ADDENDUM #2

Coastal Carolina Community College
Learning Resources Center
First Floor Renovation
SCO ID: 23-26060-01A

This addendum forms a part of the contract documents and modifies the original drawings and project manual dated November 2024. The enclosed additions, deletions, corrections, and changes shall be as binding as if incorporated in the original documents. All General Conditions, Special Conditions, etc. as originally specified shall apply to these items. Acknowledgement of receipt of this addendum will be required as part of the contract agreement.

Sheet No.
F0.1
Addendum #2
Attachment #7

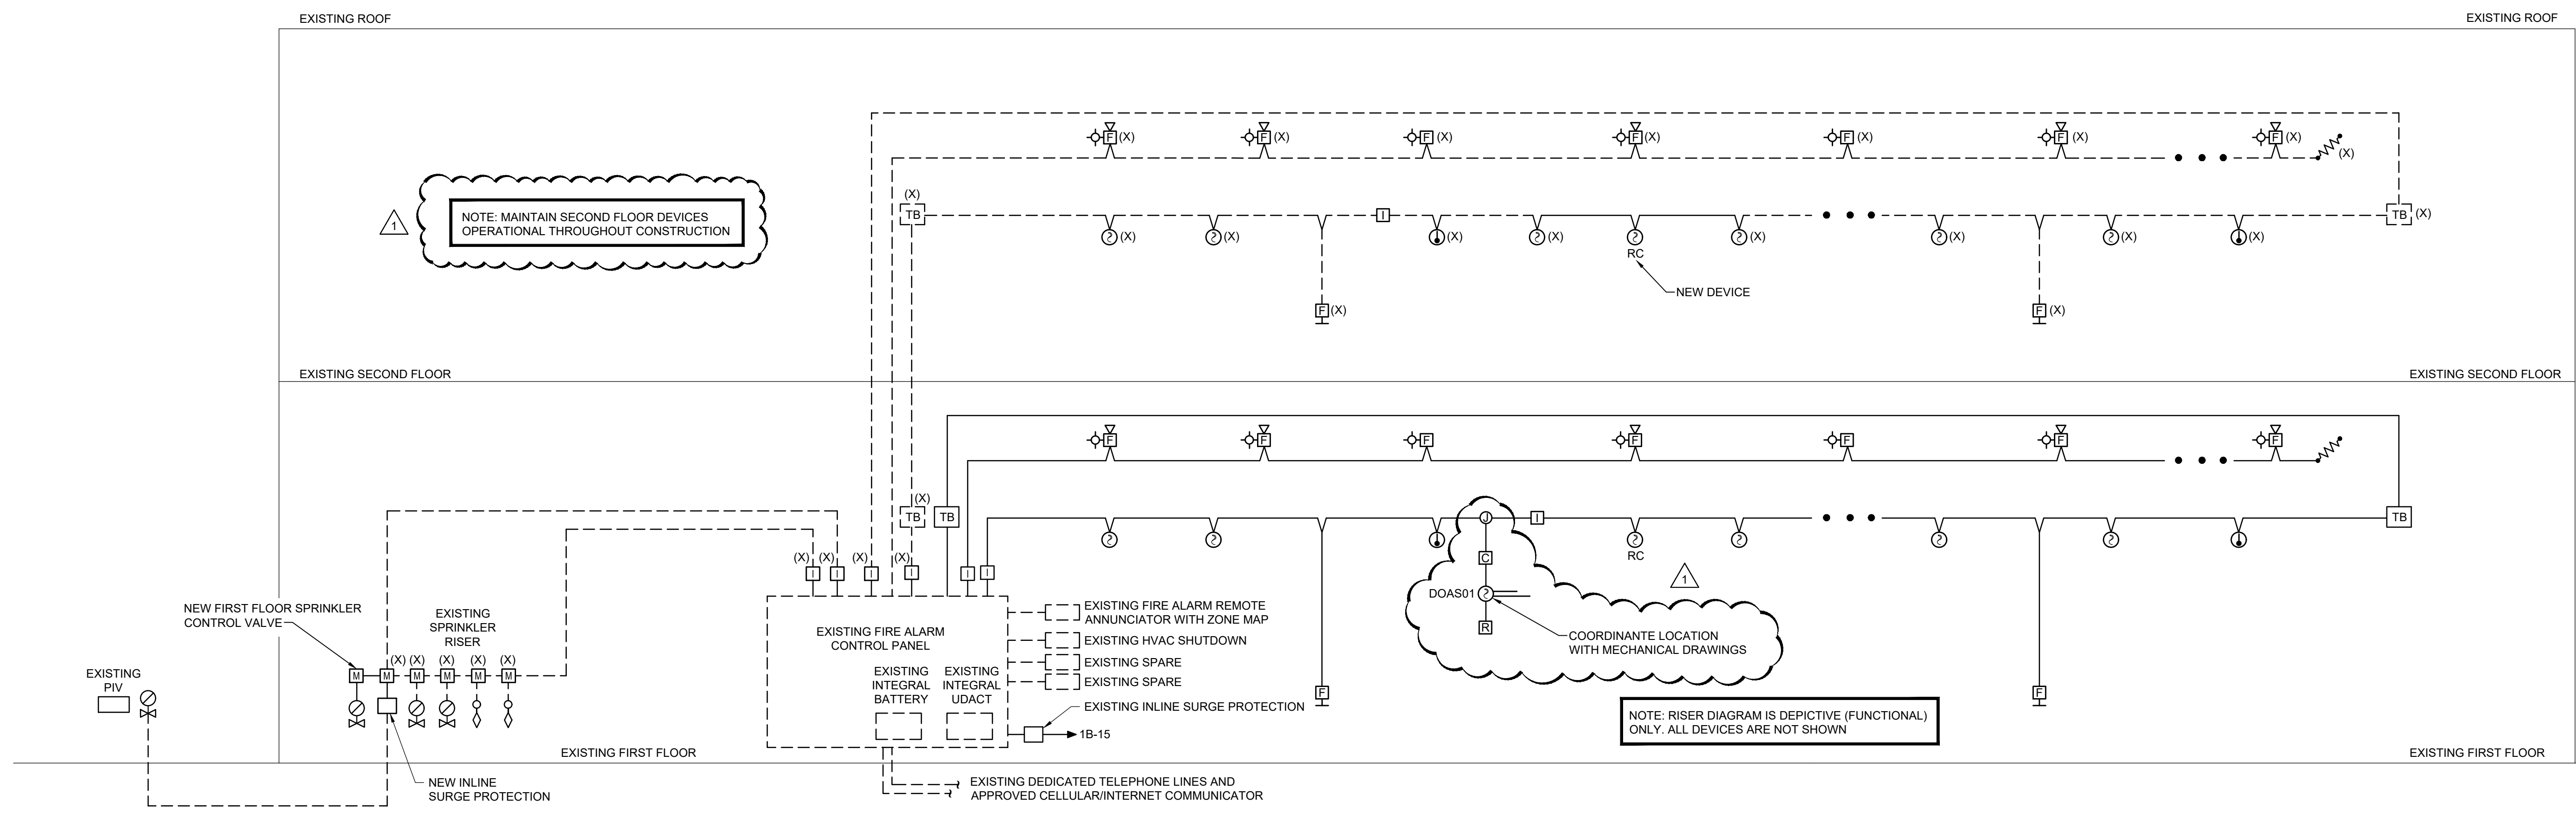
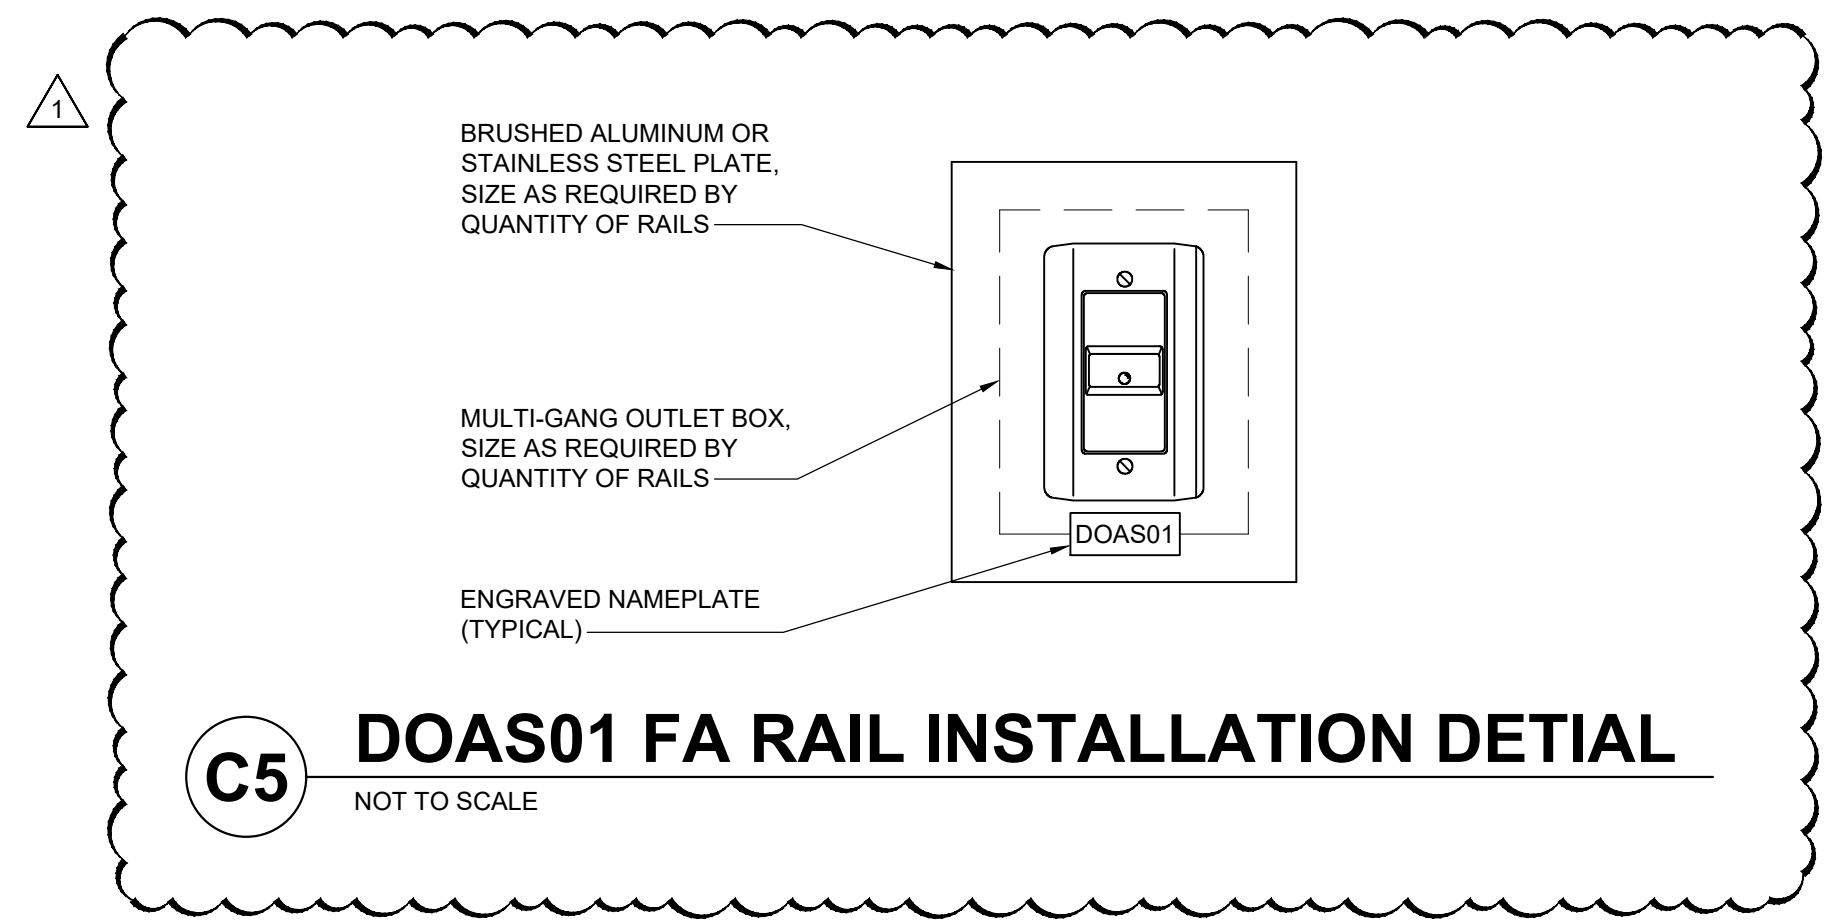
Item 11 Fire Alarm Drawings F0.1 and F1.1

Drawing sheet F0.1 has been revised to include a requirement for Fire Alarm Shop Drawings and a Fire Construction permit application to be submitted to the City of Jacksonville during construction. Revised drawing sheet F0.1 has been included as **Attachment #7.**
